E4356A-04

S E R V I C E N O T E

E4356A - TELECOM DC POWER SUPPLY 0-80V, 0-30A,
2100 W. GPIB

Serial Numbers: MY41000101/ MY41000708 SG41000101/ SG41000270

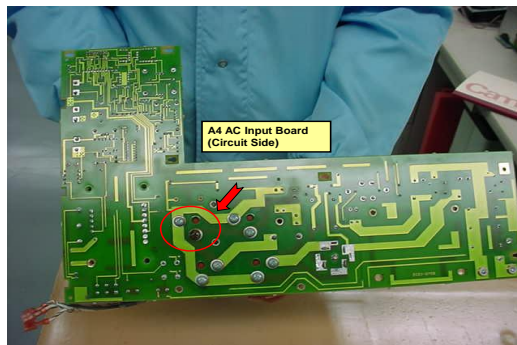
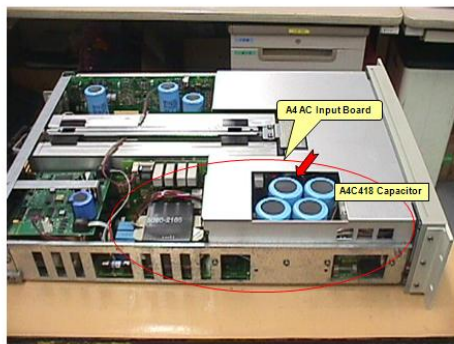
The four filter capacitors circuit reference (C416-C419) on the A4 AC input board starts leaking electrolyte - not through the pressure valve in the bottom as one would expect but through one of the terminal screw bushings.”

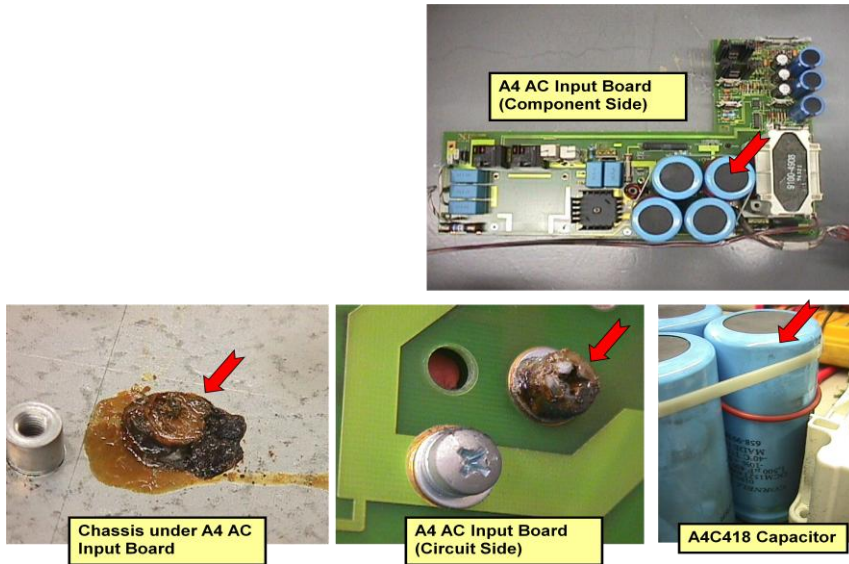
The screw P/N 2680-0217 length currently being used was not considered and the length was overlooked. The screw length is 0.375 inches long. We have found that the screw can be 0.055 inches too long and may bottom out causing the tapped hole in the header of the capacitor to become cracked or become broken.

When this happens the electrolyte will slowly leak out over time, and cause the defect described. This situation is even worse due to the capacitor is mounted with the header face down. If the capacitor was mounted header face up a cracked or broken header would not have caused this problem, the electrolyte could not leak out.

1. All affected models and tested assemblies WIP (Work In Process), FGI (Finished Goods Inventory) at SPO (Support Parts Organization) & AMC (Asian Manufacturing Center) has been inspected for capacitors with damaged headers due to the incorrect screw
2. When this repair is being done all of the hardware described above should be replaced (It is NOT recommended that any of the hardware be reused)
3. The following figures can be used when doing the repair.
4. Inspect the assembly as described below.
5. The last figure will aid in the reassembly of the hardware and the capacitors.
